Re: Townsend Farms Business Park, ECSI# 4230

The Oregon Department of Environmental Quality (DEQ) has completed review of the report entitled "Ethylene Dibromide in Groundwater – Occurrence, Hydrogeology and Possible Sources" (Report), dated December 2, 2016 and prepared by EVREN Northwest, Inc. (EVREN) on behalf of Townsend Farms, Inc. (TFI). DEQ's detailed comments on the report are included with this letter as Attachment A.

Attachment A:
DEQ Review Comments on
Ethylene Dibromide in Groundwater – Occurrence, Hydrogeology and Possible Sources
Dated December 6, 2016

Re: Review and Comments for *Ethylene Dibromide in Groundwater – Occurrence, Hydrogeology and Possible Sources*, by EVREN Northwest

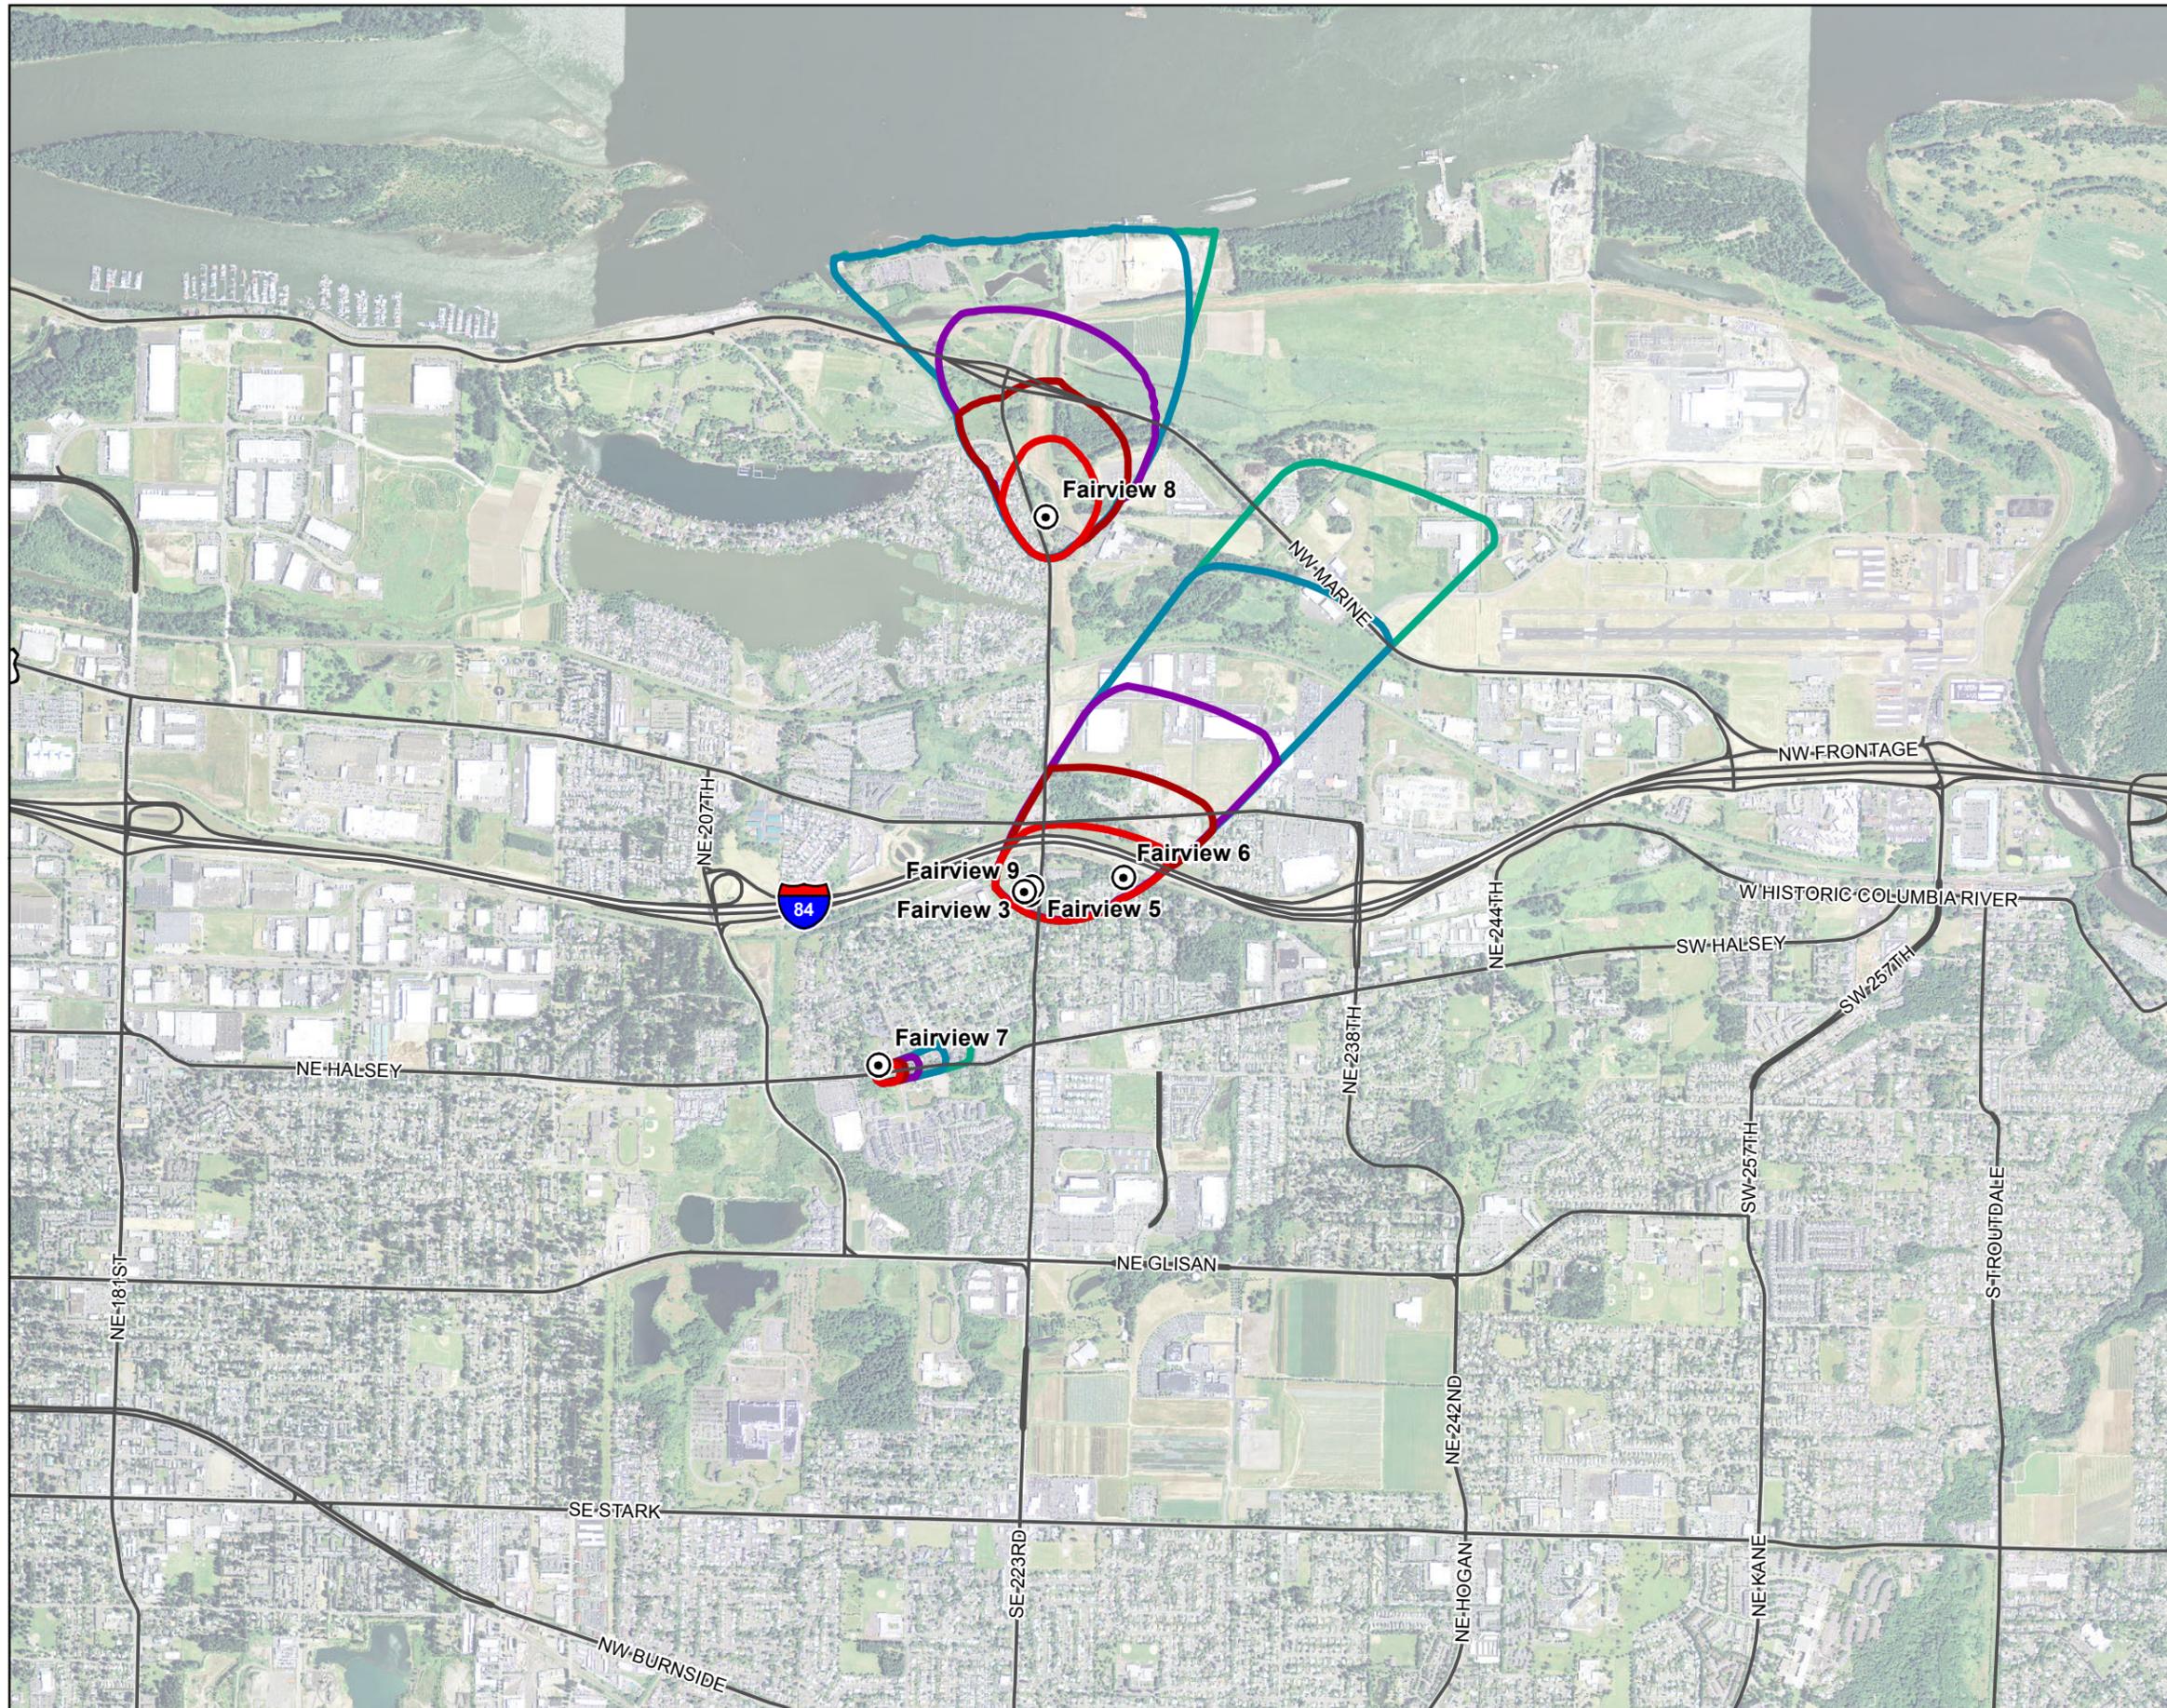
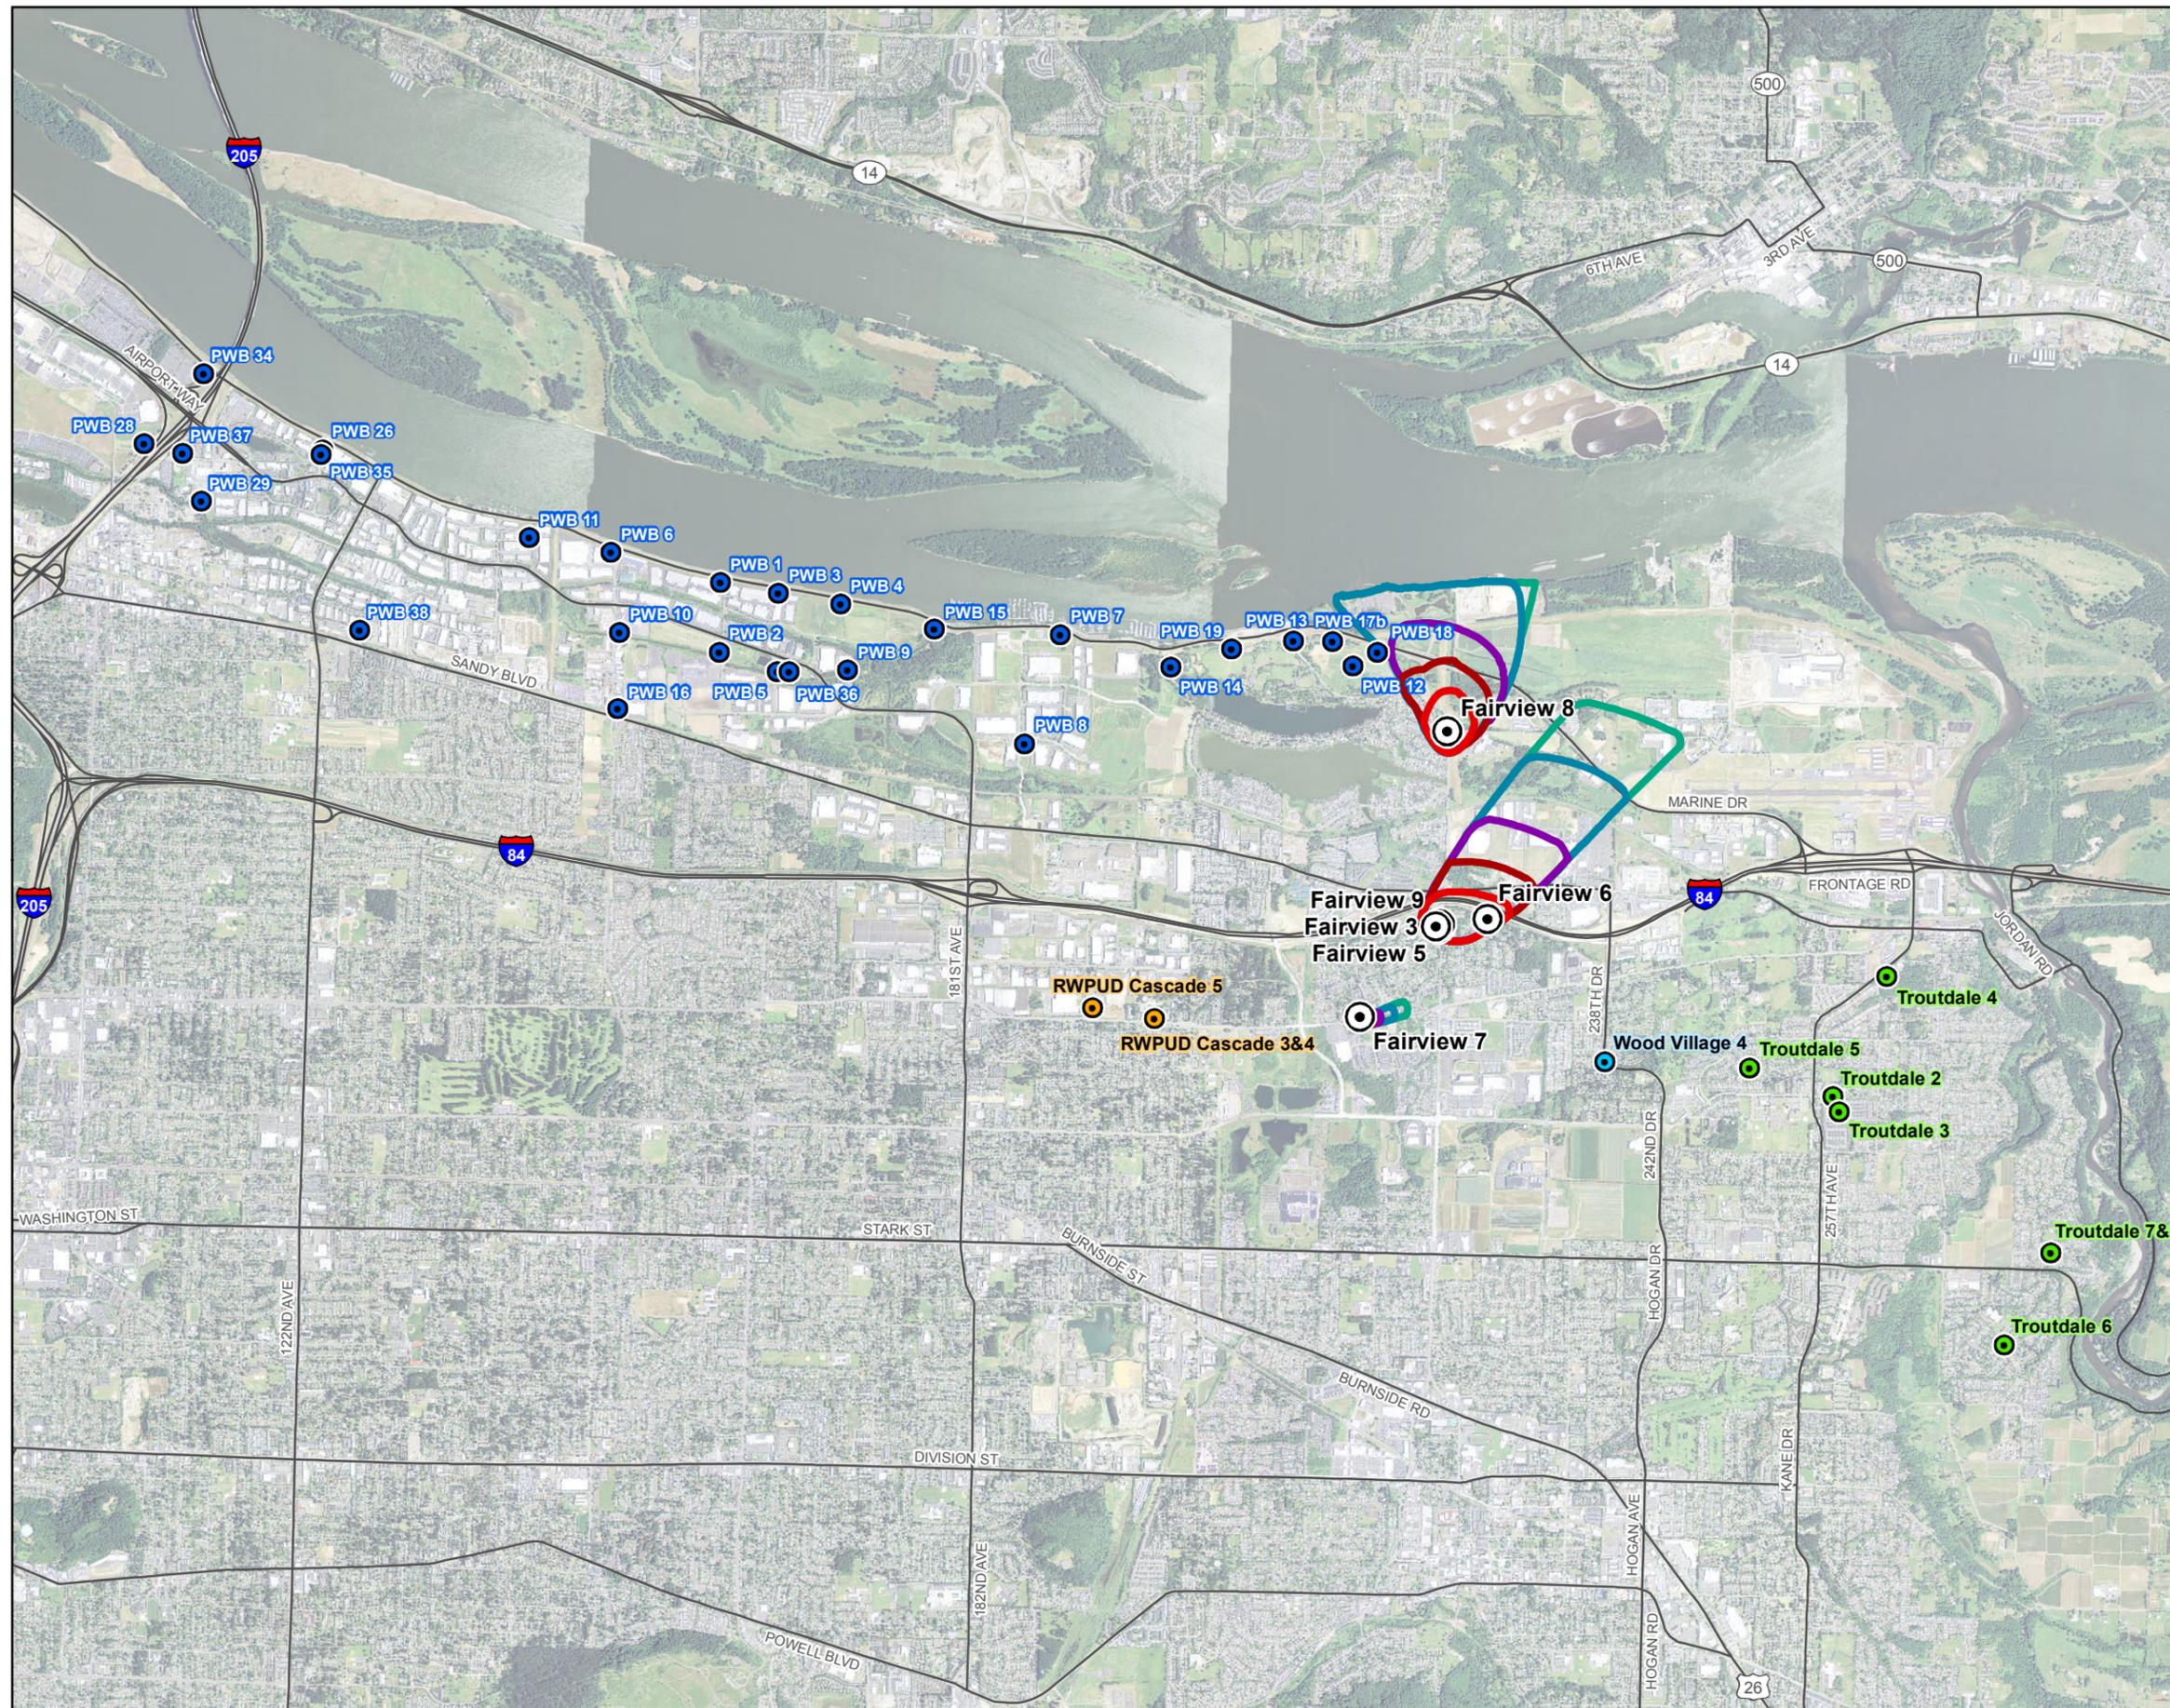
Attached are figures showing the capture zones delineated for the City's wells using the DAY Model. These delineations incorporate the effect of pumping of all other major SGA, TSA and BLA production wells, based on typical operational practices and production records obtained from each municipal entity. The capture zones delineated for the City's wells using the DAY Model show that the City's wells draw water from the north and northeast. Capture by City Well 8 is heavily influenced by the SGA connection with the BLA and Columbia River through the erosional window in

The capture zones utilized by ENW in its report were obtained from the DEQ Profiler site. These capture zones were delineated by the OHA DWP, likely utilizing an analytical model and imposed ambient south-to-north gradient; we surmise the gradient was assumed based on an earlier study, such as USGS Water Supply Paper 2470-A (1996). The model used by OHA DWP does not appear to incorporate major boundary conditions (e.g., the connection with the river), the influence of other pumping centers, nor the changes in the regional flow field over the past several decades. The resulting modeled capture zones are thus determined by the assumed regional ambient gradient imposed in the model and do not reflect the actual gradients present in the area since the late 1990s. The resulting capture zones suggest that all City wells primarily capture water from a southerly direction, which is highly unlikely. The City is in the process of providing the OHA DWP with the capture zones delineated with the DAY Model and supporting documentation, and will be requesting that these capture zones delineated by the OHA DWP be replaced by those delineated using the DAY Model.
